City of Detroit
Inter-Departmental Communication

DATE: July 16, 2018

RE: Petition No. 1759
Requested Encroachment Into The East/West Alley At 2001 Woodward With A
Compressor Platform

PROVISIONS FOR ENCROACHMENT For Petition 1759

CITY OF DETROIT
 CITY ENGINEERING DEPARTMENT
 SURVEY BUREAU
 JOB NO. 01-01
 DRWG. NO. X 1759

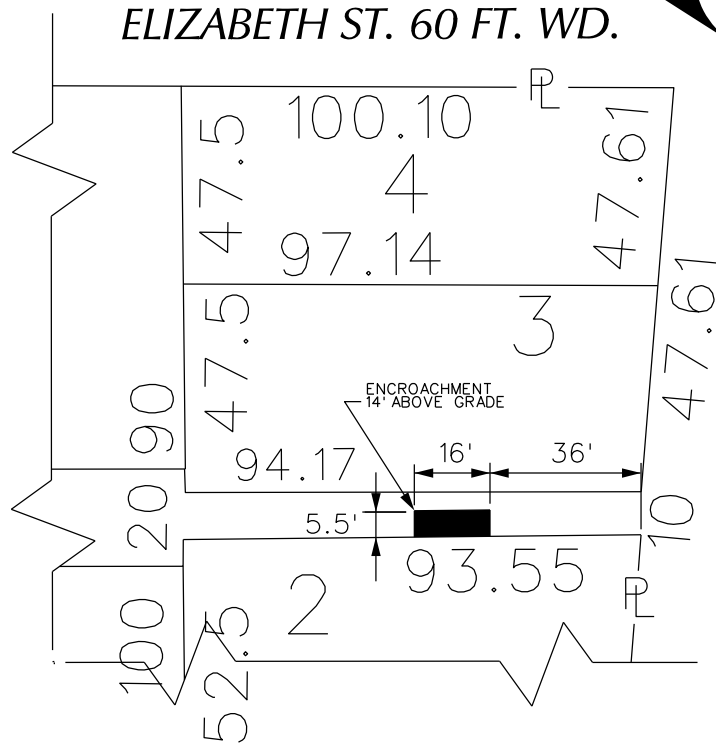
- DWSD has water main and sewer in the area of the requested encroachment. DWSD has no objections to the requested encroachments provided that the attached provisions for encroachment are strictly followed.

2. DWSD requires a vertical clearance of 18 feet above grade for maintenance excess and repair.
3. All construction performed under this petition shall not be commenced until after five (5) days written notice to DWSD. Seventy-two (72) hours notice shall also be provided in accordance with P.A. 53 1974, as amended, utilizing the MISS DIG one call system.
